PIC18F04/05/14/15Q41 Silicon Errata and Data Sheet Clarifications

The PIC18F04/05/14/15Q41 devices that you have received conform functionally to the current device data sheet (DS40002242D), except for the anomalies described in this document.

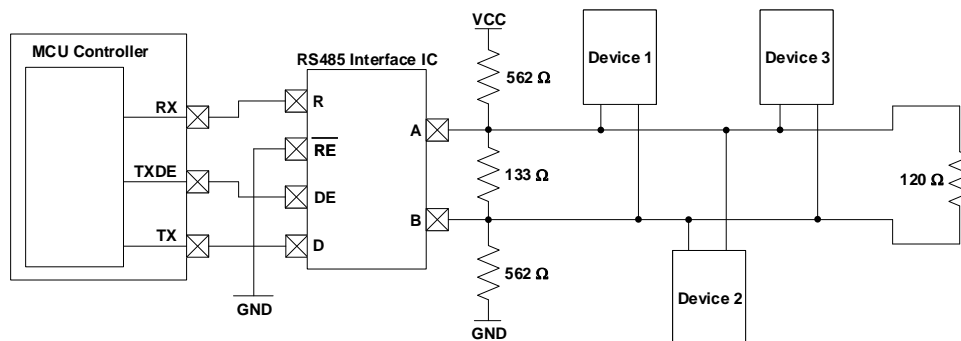
The UART Transmit Drive Enable (TXDE) signal could potentially transition into a low state before the UART STOP bit has been entirely transmitted due to the effects of parasitic capacitance on the TX line. In some applications, this could result in communication being prematurely terminated due to the TXDE bit going low before the STOP bit has had enough time to settle.

In order to ensure that the STOP bit settles into its final logic state before the TXDE signal transitions low, a biasing circuit can be implemented. A biasing circuit allows the TX line to either be driven high or low, rather than being left in a floating tri-state mode where prolonged rise or fall times could lead to communication being disrupted. This bias circuit should only be implemented on one end of the serial bus, and a termination resistor should be used on the other end. The figure below show an example of a bias circuit that can be used to achieve this. Please note that the resistor values used in this circuit are recommendations, and that the actual resistor values required may vary based on the application.
